## **Bid Package 02 - Construction Bulletin 05**

**05/05/2020**

**Canadian County Expo Center  
3001 Jensen Road East  
El Reno, OK 73036**

## ALT #1 KEYED NOTES

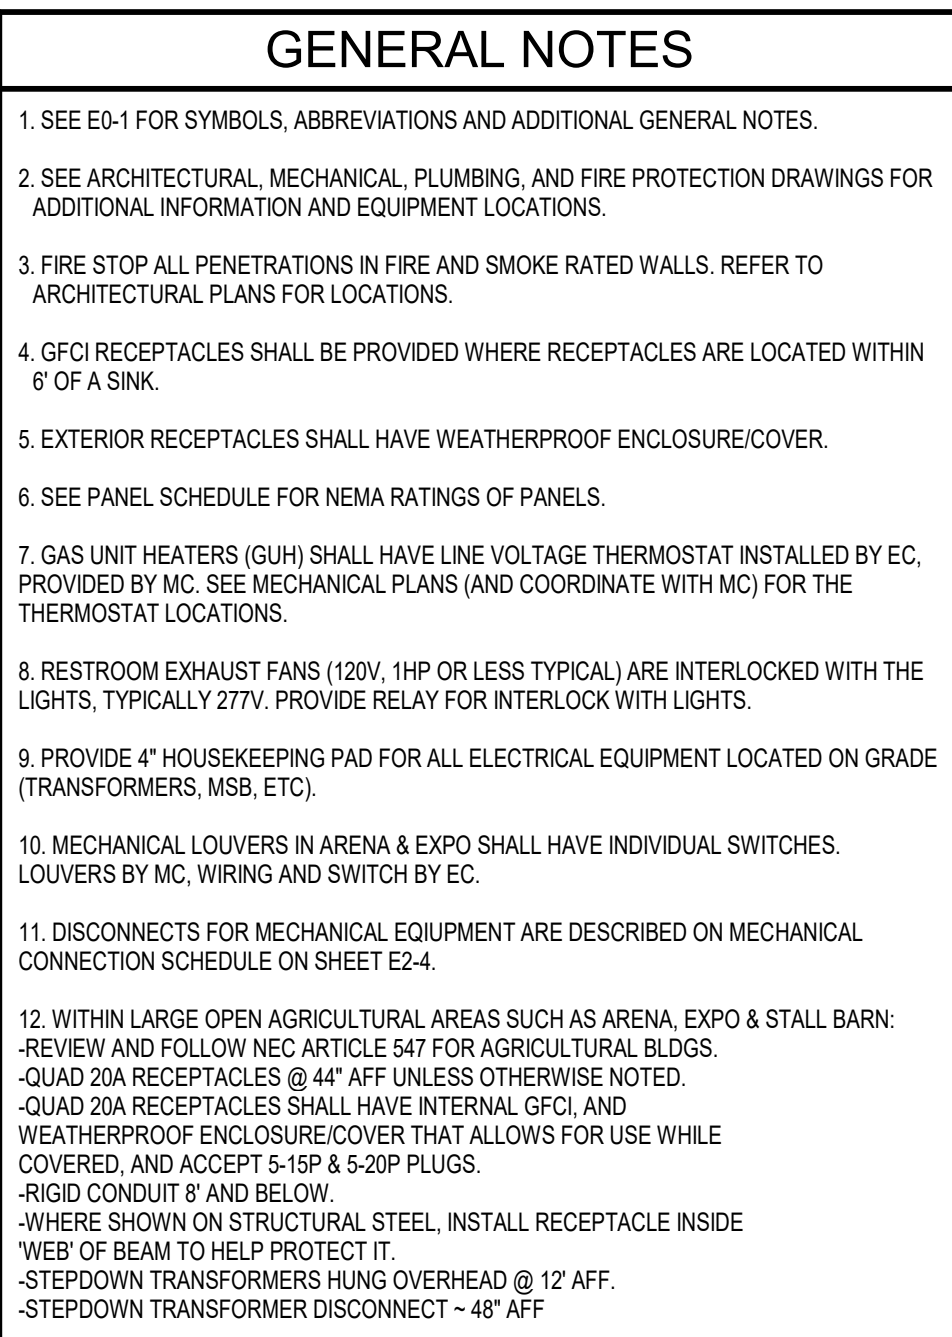
- a. Added a keyed note 2, gives clarification on corral panel power intent.
- h. Sheet E2-3 Electrical Roof Plan
  - a. Added EF-5.
- i. Sheet E2-4 Electrical Connections Schedule

- Added a keyed note 2, gives clarification on corral panel power intent.
- Sheet E2-3 Electrical Roof Plan
  - Added EF-5.
- Sheet E2-4 Electrical Connections Schedule

# 1 ELECTRICAL ONE LINE DIAGRAM

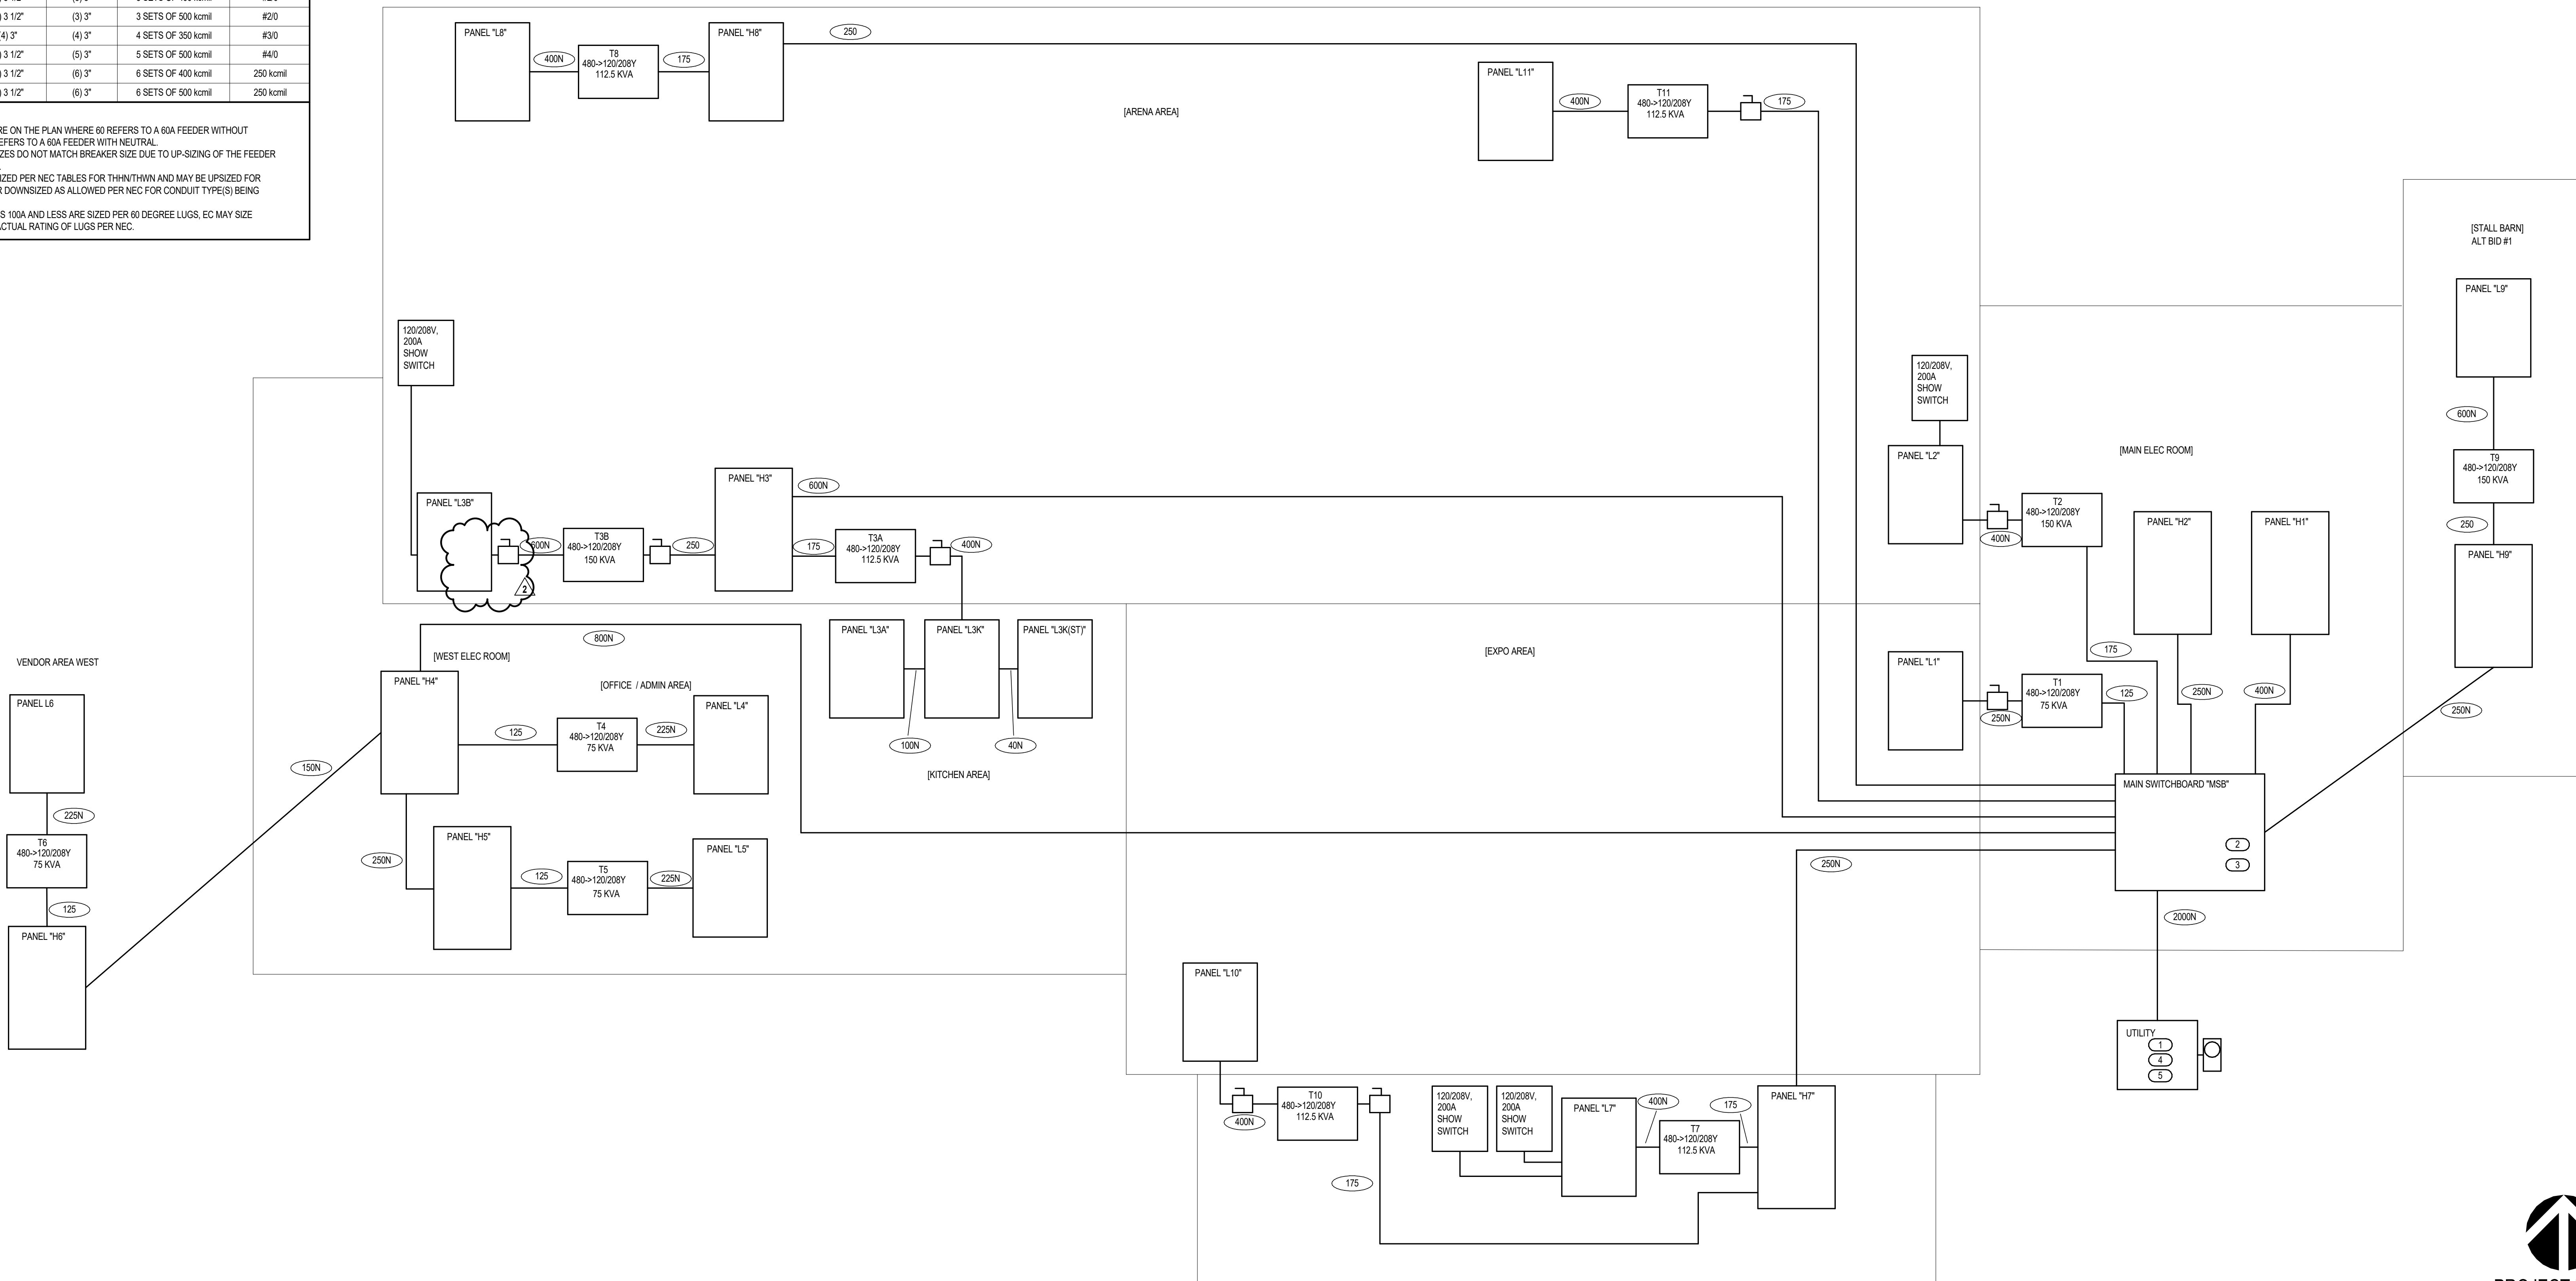
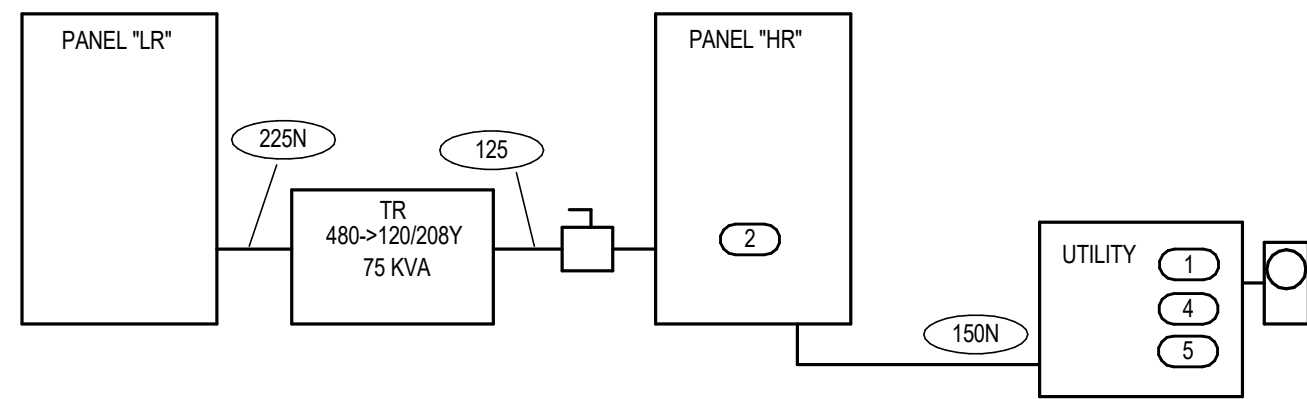
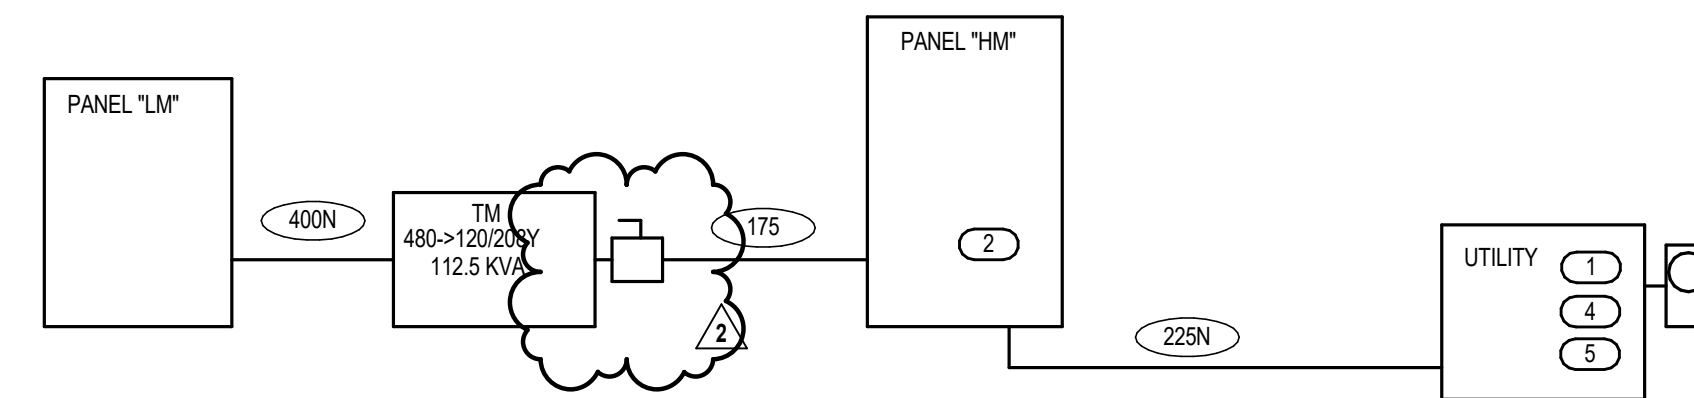
- a. Edited two disconnects.
- l. Sheet E5-2,-3, -4, -5 Electrical panel schedules sheet
  - a. Added Breakers etc to reflect changes on the floor plan sheets.

- Added EF-5.
- Sheet E3-2 Electrical PA/AV Systems Plan
  - Clarified conduit size for speaker cable, 3".
- Sheet E4-1 Electrical one line diagram
  - Edited two disconnects.

## 1 TYPE 'P' POLE BASE DETAIL

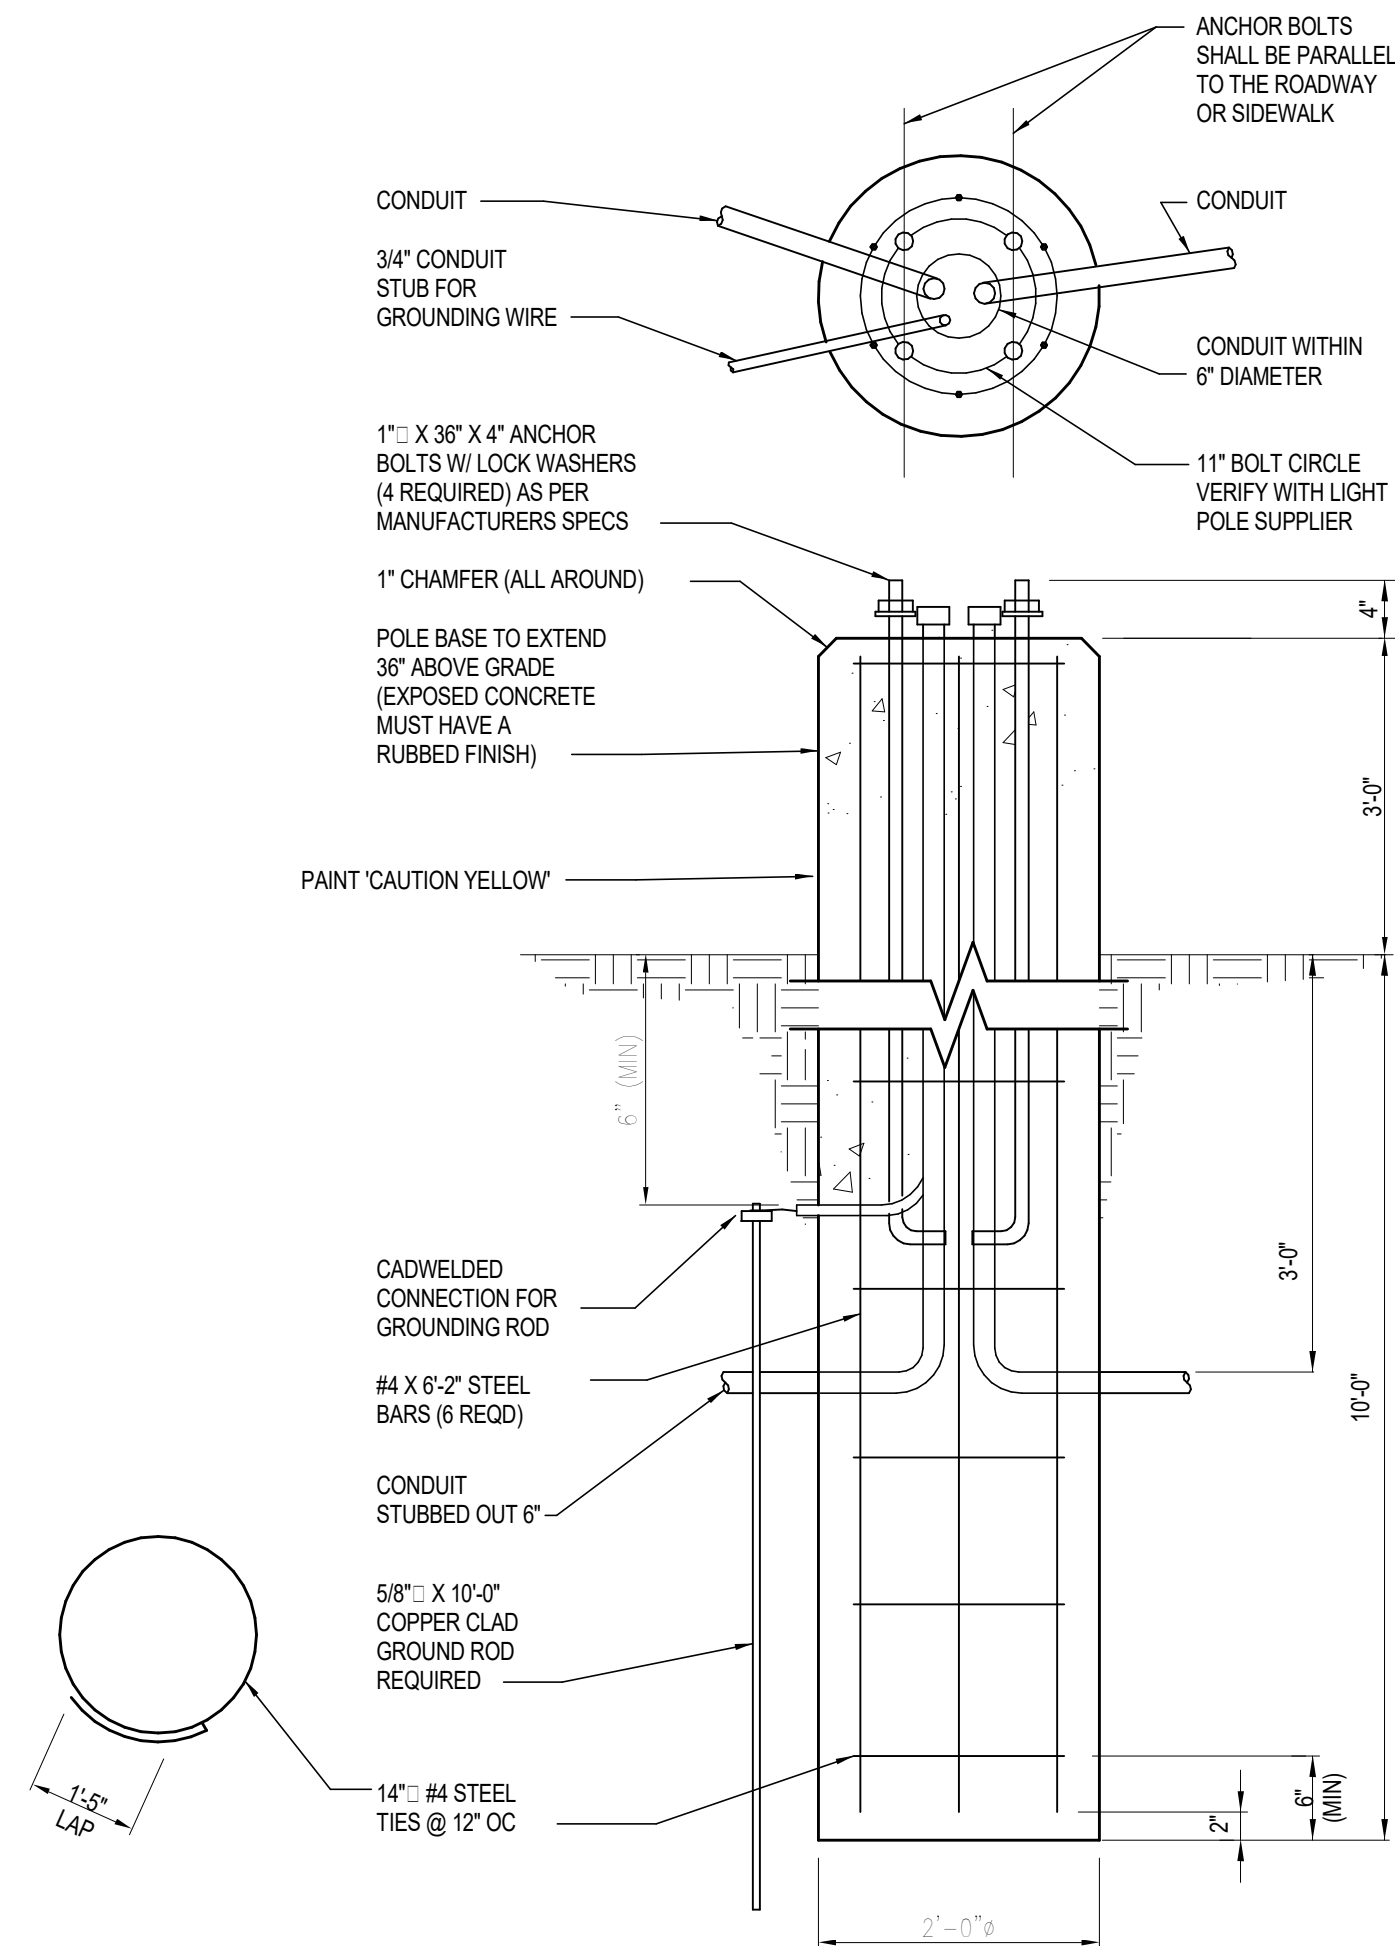
44. Clarification: Refer to page E3-2, keynote #3. This states to provide conduit for audio cables. What size of conduit is wanted? 3" conduit.
45. Clarification: Refer to page E6-2, detail 1. What is the comment 6" conduit stub refer to? I'm assuming you want a 1" conduit stubbed 6" out, and not a 6" conduit stubbed out? True 1" conduit stubbed 6" from concrete base, detail edited.

#### **4 LIVESTOCK CORRAL PANEL DETAIL (ALT BID 1)**

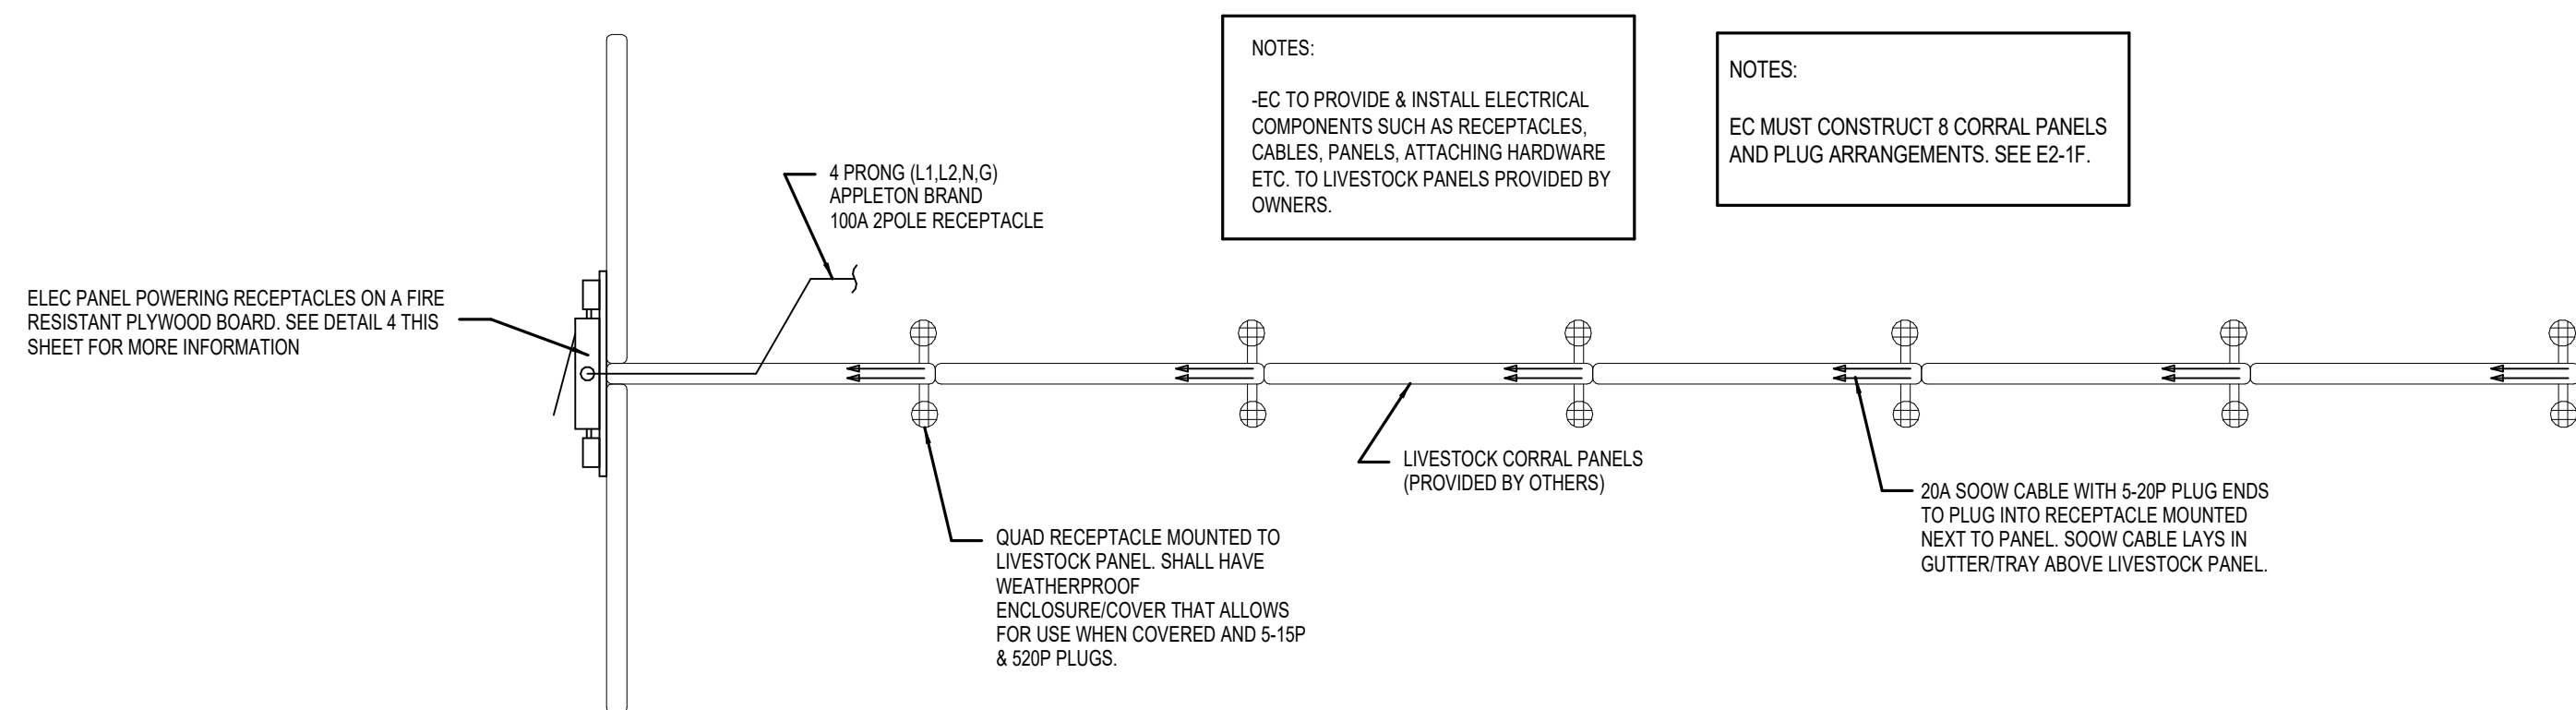
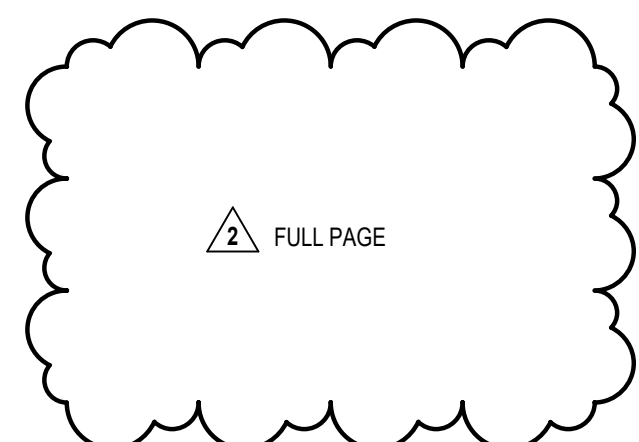
- m. Sheet E6-2 Electrical details sheet.
  - a. Edited detail 4 and 7, livestock corral electrical.

46. Clarification: Refer to page E6-2, detail 4&7. Where is the location of these details on the prints? Where does this apply? Those livestock panels are modular movable panels. They are shown on E2-1F. drawing edited to show there are 8 instances of the elec panel, and quads mounted to the panels that get power by plugging into the receptacles that are powered by the 100A panel. These are part of Alt 1 Bid (stall barn). Detail edited, included in AD03.

- Edited detail 4 and 7, livestock corral electrical.
